pd-trigger — Design Document

ai-ee v1 pipeline

Board review (P8 adversarial) - pd-trigger

5 Schematic

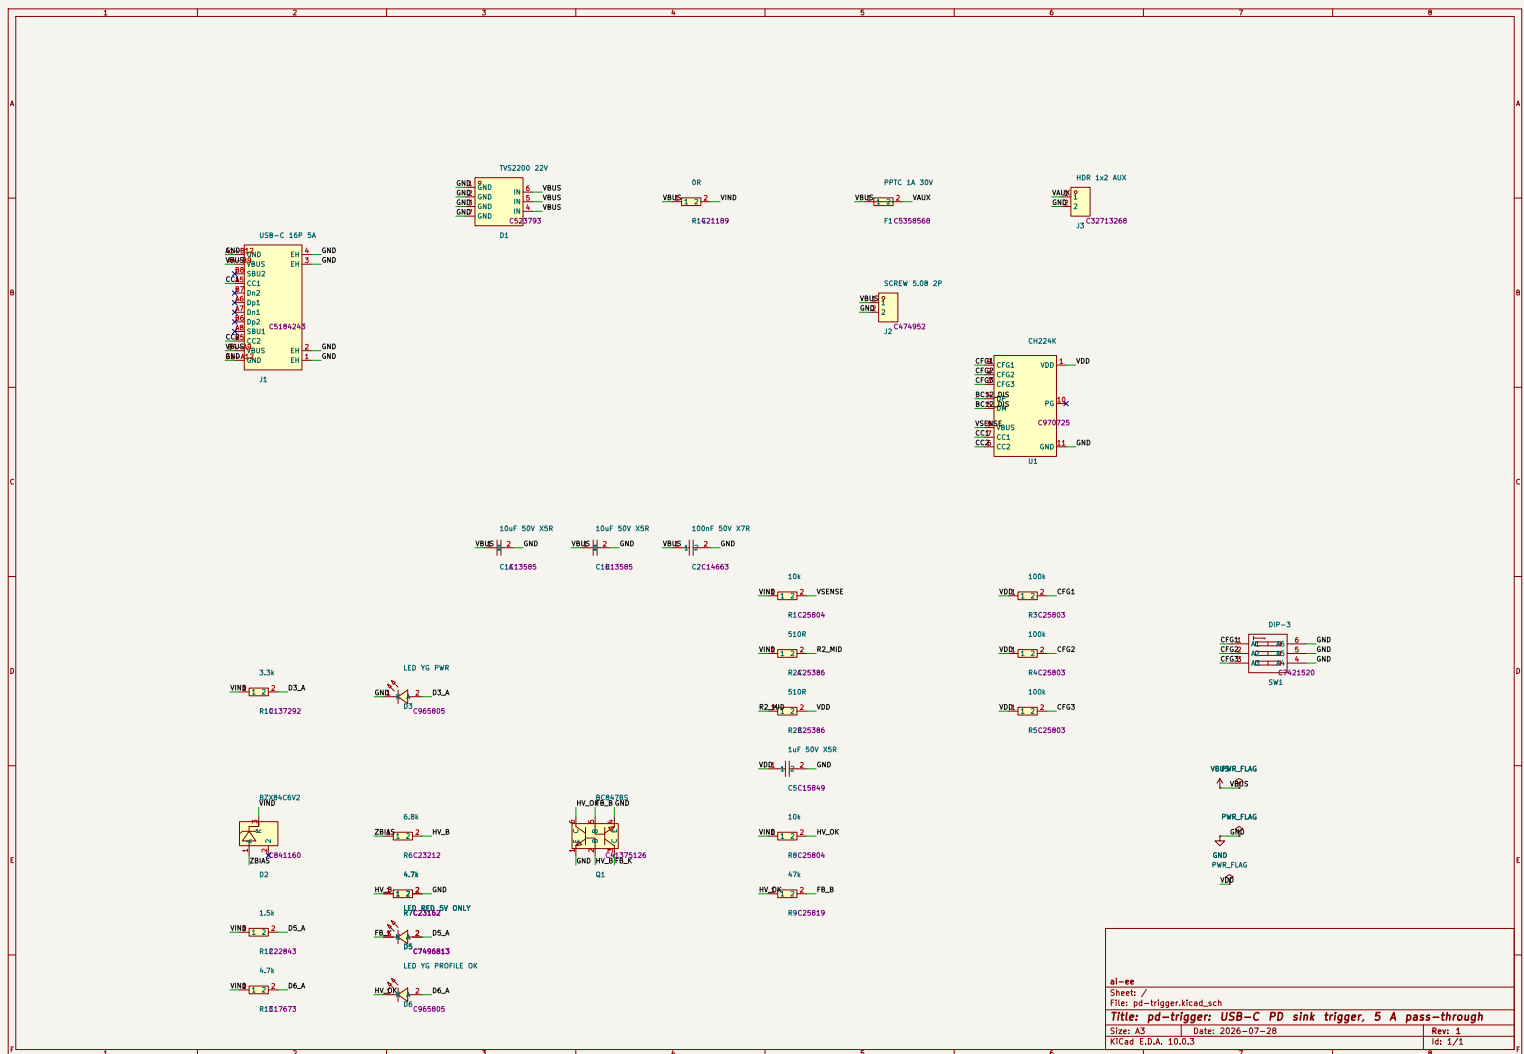
W1 dp-dm-short-at-chip: architecture's PD-only short (/BC12.DIS) ACCEPTED by the reviewer as hardware-SAFER than the datasheet's connector wiring (removes a 21V-onto-3.8V-abs-max fault path). Cost: no QC/BC legacy support - the board is "PD sources only"; goes on B.SilkS + order docs. W2 vdd-worst-corner: true worst case 0.979mA at 4.4V low-line all-straps- closed vs unpublished CH224K IDD - bounded by WCH's own reference circuit; V1 bring-up step: measure VDD at the 5V profile; contingency = both 510R -> smaller (documented floor 600R total). Bring-up addenda: buzz out Q1 E/B/C once (clone PDF JS-gated; Nexperia- standard pinning verified as the compatibility claim).

```
reports/render_final/top.png
```

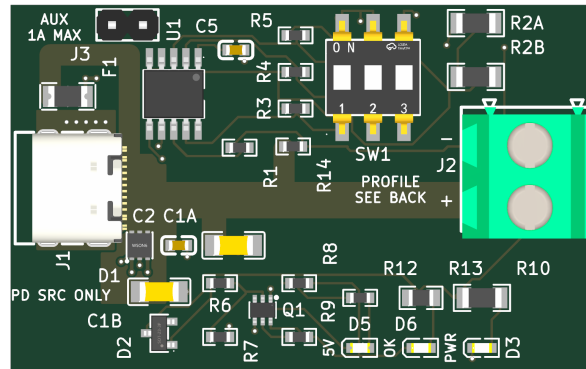
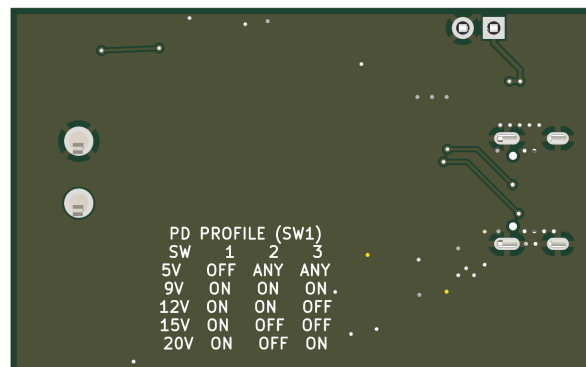
E1 - 5 A return chokes at J1's GND contact pads (error, checker-blind by design D7)

The 4 GND cable contacts land on two merged SMD pads (F.Cu only): A1-B12 at (17.63,39.31) and B1-A12 at (17.63,45.71), nominally 2.5 A each at the 5 A rating. Their ONLY copper into the B.Cu return pour:

- A1-B12 (top): a 0.2 mm wide, 2.7 mm long F.Cu chain (3 segments) into shell pad 1's THT barrel, plus one 0.6/0.3 via whose annulus grazes the pad corner by ~0.05 mm (etch-tolerance-level). 0.2 mm at 2 oz = 0.80 A capacity at 10 C rise (pipeline model); at 2.5 A the same model gives ~133 C rise (short-neck heatsinking will moderate this, but it is a >3x overcurrent on the model's own terms). ~13.6 squares = 3.3 mohm.
- B1-A12 (bottom): a 0.2 mm x 1.3 mm trace into ONE 0.6/0.3 via. The board's own via budget (constraints via_amps 0.5) says 2.5 A needs 5 vias; there is 1. Shell pad 4 sits 0.32 mm away but is NOT connected on F.Cu - its copper does not help.

Architecture D7/power_tree structural requirement ">= 10 vias at J1's GND pads" (the stated substitute for keeping GND out of power[] so check_current stays quiet): not delivered. DRC cannot see it (0.2 mm is netclass-legal), check_current cannot see it (GND undeclared), check_return_path no-ops (no high_speed key). Failure mode: sustained 5 A at any profile heats the two necks far past the 10 C design intent; long-term trace/joint fatigue, intermittent ground, and full return current cascading onto the surviving 0.2 mm chain. Fix is cheap at P9: an F.Cu GND spandrel bonding each contact pad to its shell pad (the VBUS pour top edge is at y 39.7 - the strip above it, and the strip x < 17.2 plus the region south of y 46, are free) plus 4-5 vias per side.

E2 - Safety/waiver silk markings absent (error, promised artifact) Board-wide gr.text count is ZERO; B.SilkS carries nothing at all (both B.SilkS references in the file are the stackup layer table). Missing, each one a written promise:

- AUX 1A MAX + V+/GND at J3 (P0 answer 4 "silk-marked", V10). F1 makes overload safe-by-hardware, but polarity of the 2-pin aux header is unmarked.
- PD SOURCES ONLY (ERC waiver W1's standing condition: "goes on B.SilkS + order docs"). The waiver's silk half is currently unfulfilled.
- J2 screw-terminal polarity. Trunk lands on J2 pad 1 = the LOWER screw (board-bottom side); nothing anywhere tells the bench user which screw is V+. Reverse-wiring a load on a 100 W output is the single easiest field mistake this board can cause.

E3 - User-interface silk absent (error, promised artifact)

- The five-row profile table on B.SilkS - D3 calls silk "the user interface" and specifies the table verbatim; the bottom is a clean pour with room. Without it the ON/OFF-to-voltage map exists only off-board; a user WILL set 9 V expecting 12 V by trial and error. (Fail-safe floor: any wrong guess >= the 5 V fallback, and OFF-fail = 5 V - the mistake is bounded but real.)

- LED legends PWR / 5V ONLY / PROFILE OK (D4/V10): the render shows refdes D3/D5/D6 only. The entire P0-answer-6 "visible fallback indication" scheme is mute without the words - a lit red LED labeled "D5" indicates nothing.

W1 - J1 mouth recessed ~0.4-0.5 mm behind the board edge (warning, flagged at P6) Courtyard/silk front edge $x = 10.18$ vs board edge $x = 9.8$. USB-C receptacles are normally flush-to-overhanging; a recessed mouth lets thick/molded plug overmolds butt the board edge and hold the plug fractionally short of latch - intermittent CC, no PD, "works with some cables". On a bare bench board with arbitrary cables this is a real annoyance risk. Fix: nudge J1 -x 0.5-1.0 mm at P9 (pour edge follows; nothing else in that corridor), or accept and note in order docs.

W2 - Outline 48 x 30 mm exceeds the architecture's hard ceiling (warning, drift) Edge.Cuts = (9.8,27.51)-(57.8,57.51) = 48 x 30 mm. D9: nominal 45 x 25, "hard ceiling 48 x 28 mm"; 30 mm violates D9's own ceiling by 2 mm even though it equals P0 answer 5's literal +20 % (40x25 -> 48x30, +44 % area vs the brief's target). No digest discloses the growth past D9. Consequence is cost/footprint only, but it must be disclosed to the user at the checkpoint rather than discovered.

```
# P8 digest (pd-trigger)
verify PASS 8/8 first try. Fable reviewer: 4 err + 2 warn. Copper errors
REAL: 5A RETURN choked at J1 GND pads (0.2mm necks/0.80A, 1 via) - rebuilt
w/ priority-1 F.Cu GND lobes (connect.pads solid) + 15 new 0.6/0.3 vias ->
5.68A/4.70A per pad, 16 vias (D7 >=10 met). Removed 2 stitch vias 0.121mm
from THT drills - LIVE-PROVEN KiCad DRC blind spot (via-drill vs same-net
pad-drill never checked, finding 34). Silk errors: 17 texts added; agent
CORRECTED the orchestrator's B-table spec (raw CFG bits would be inverted
vs ON=GND switch reality - printed switch positions). Warns: mouth recess
-> order docs; outline 48x30 deviation recorded; C1B channels waived w/
numbers. Re-gates: drc_routed 0/0, verify 8/8. H4 AUTO-approved.
```
